Original Development Assessment Report

Item 3.**Development Application: 212-214 King Street, Newtown - D/2025/585****File Number:** D/2025/585**Summary**

Date of Submission:	8 July 2025
Applicant:	SLR Consulting
Architect/Designer:	Richmond + Ross Consulting
Developer:	McDonald's Australia
Planning Consultant:	SLR Consulting
Heritage Consultant:	NRBS & Partners Pty Ltd
Cost of Works:	1,751,791.00
Zoning:	E1 Local Centre
Proposal Summary:	The subject Development Application (DA) D/2025/585 seeks development consent for the use and fitout for a takeaway food and drink premises known as 'McDonald's' with associated signage and hours of operation for 24 hours a day, 7 days a week. The application is referred to the Local Planning Panel for determination as it represents contentious development, with receipt of over 25 unique submissions by way of objection.

Figure 10: Proposed floor plan (indoor dining seating area outlined in red)

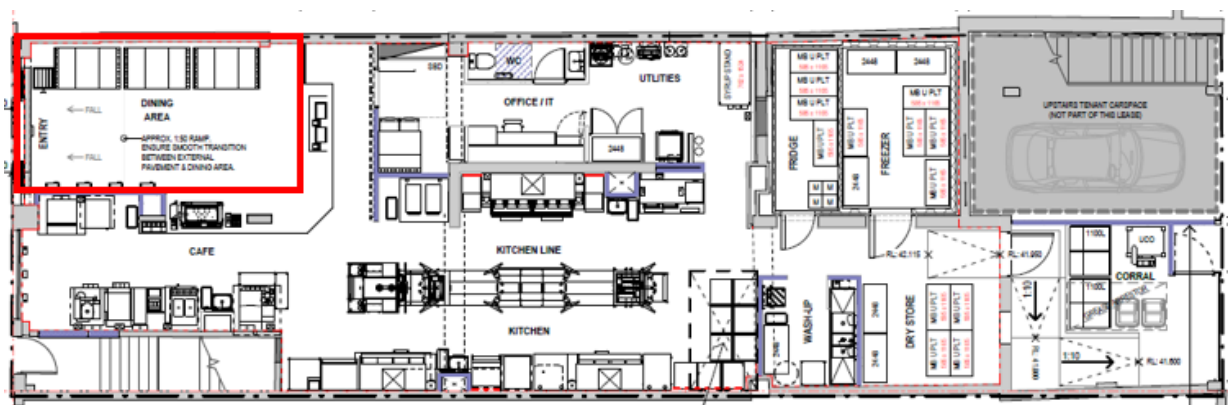
26. The proposed floor plan below shows an indoor dining area with booth seating for approximately 12 persons (outlined in red) and the rest of the floor area being a large kitchen and back of house (approximately 225 sqm or 90% of the premise's floor area). No toilets are provided for customers using the indoor dining area. Toilets are required under the NCC when there are more than 20 patrons. Only one toilet is provided for staff use which is located within the office beyond the café and kitchen. It is not clear if the toilet would be made available to delivery riders who will be regularly servicing the site.
27. The predominant service kitchen and food preparation areas compared to the dining area signifies that the majority of food and drink will be consumed away from the site. This issue cannot be addressed through the imposition of conditions or amendments to this application.
